Portland General Electric Company

Trojan Nuclear Plant
Docket 50-344
License NPF-1

I hereby certify that on July 6, 1979, Licensee's letter to the Director of Nuclear Reactor Regulation dated July 6, 1979 and an attachment entitled "Request for Additional Information, Trojan Nuclear Plant, Proposed Control Building Design", have been served upon the persons listed below by depositing copies thereof in the United States mail with proper postage affixed for first class mail.

FIGURE 6(a)-1

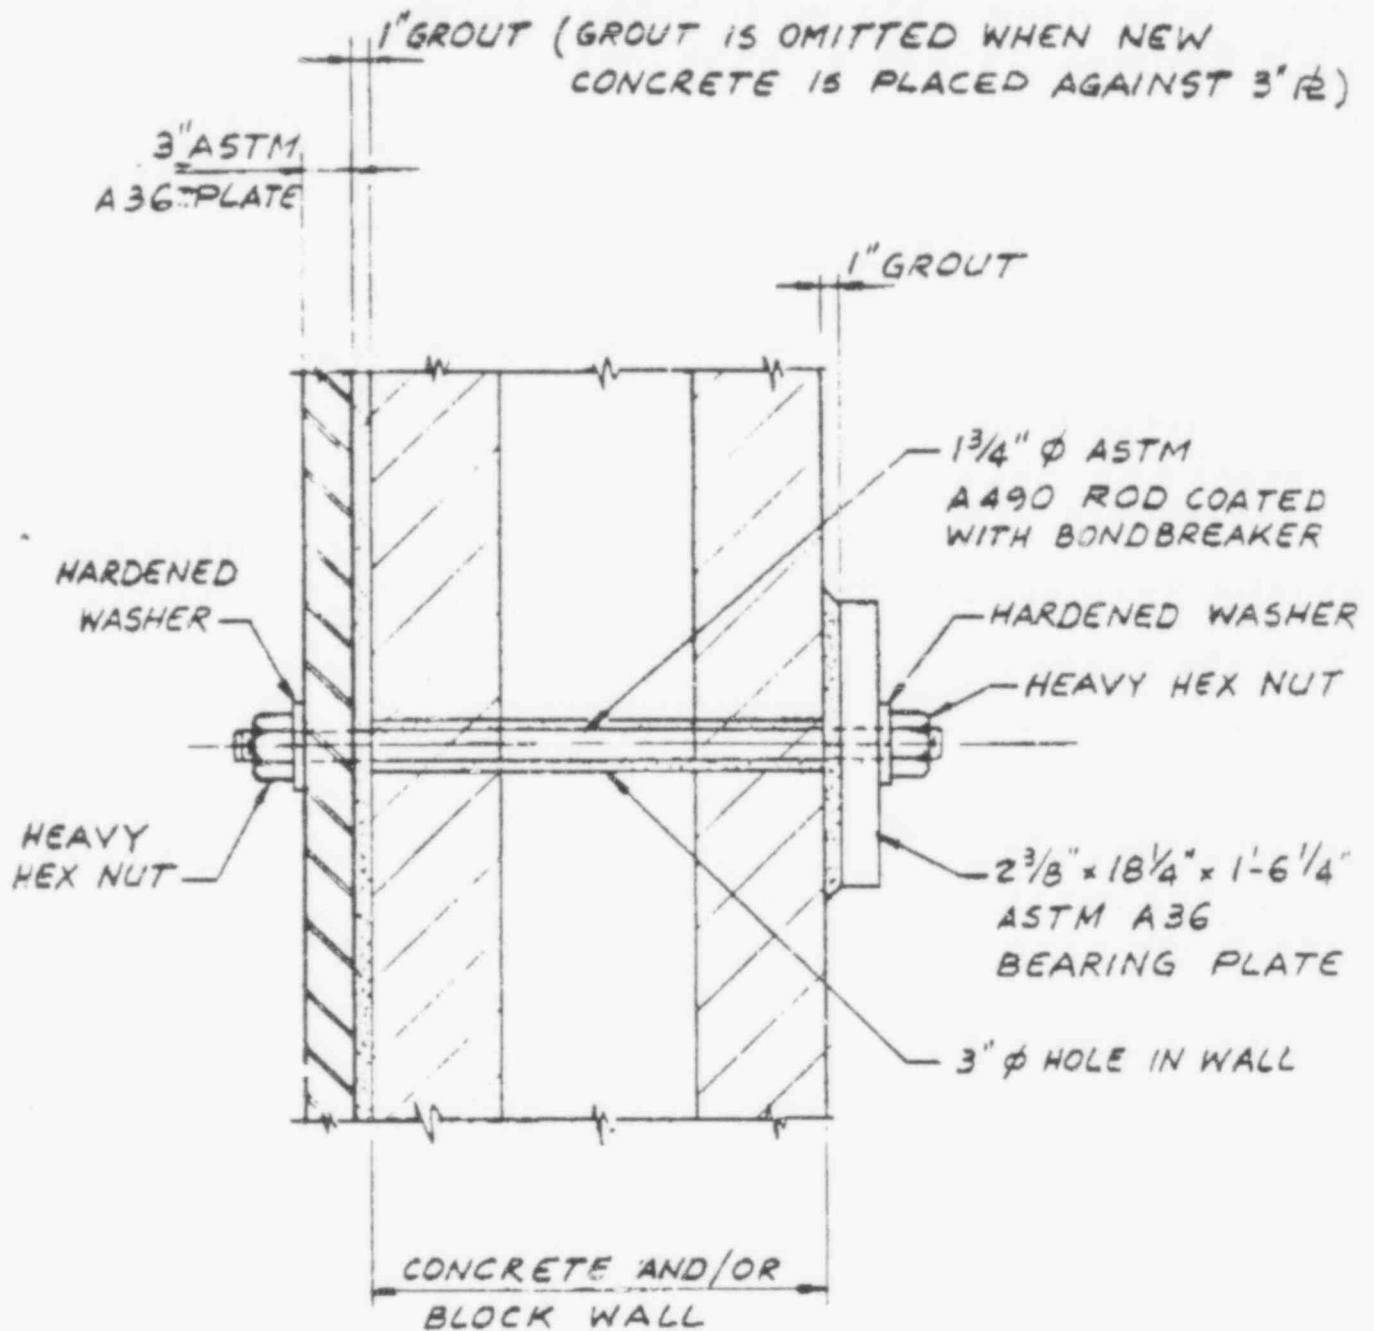
Q. 6. (a)

For the "Criteria for Bolts", provide the following:

A clear description of the bolt assembly and hardware arrangement.

The bolt assembly consists of a 1-3/4" diameter ASTM A490 rod threaded on both ends, a 2-3/8 in. thick, 18-1/4 in. by 18-1/4 in. ASTM A36 bearing plate on the inside of the Control Building, the 3" thick ASTM A36 steel plate on the outside of the Control Building, and a heavy hexagon nut and hardened washer on each end of the rod. One inch of grout will be placed between the 3" steel plate and the existing wall, and between the bearing plate and any concrete or block surface. The bolt assembly and hardware arrangement are shown in the attached figure.

Figure 43-1

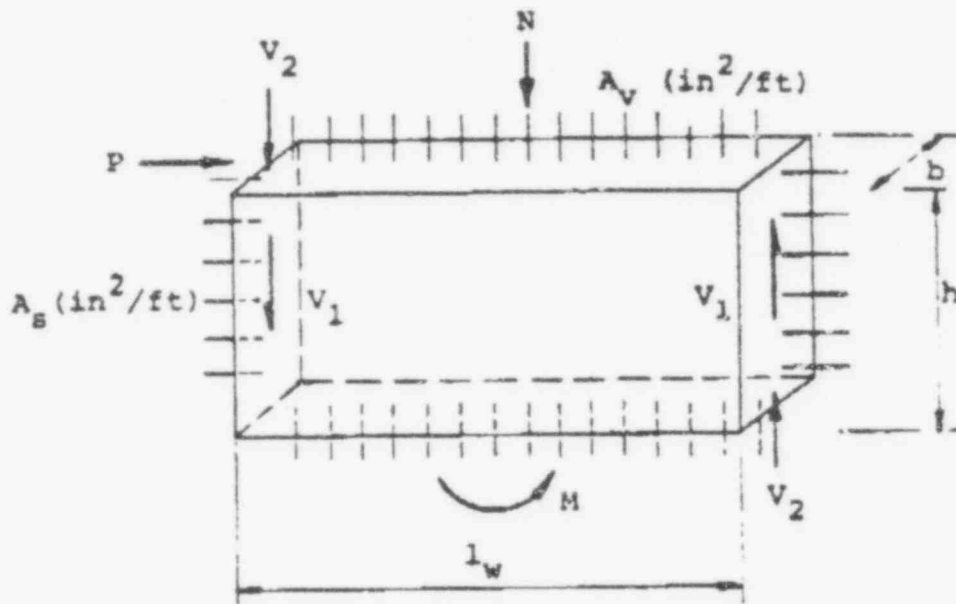
Describe in detail how the constant bending moment applied to the test specimens via the auxiliary loading system in conjunction with the main loading system compares to that which would exist due to end restraint in the actual Trojan walls, to justify the applicability to the test specimens results directly to the actual walls.

Figure 43-1 below shows the free body diagram of a typical wall panel.

Vertical shear resistance $V = V_1 + V_2$

V_2 : Shear resistance through beam-column connection:
 For illustration purpose a typical floor beam,
 W24 x 68 will be considered. The allowable
 working stress bearing values of the connection
 from AISC table I-B7 = 126 kips
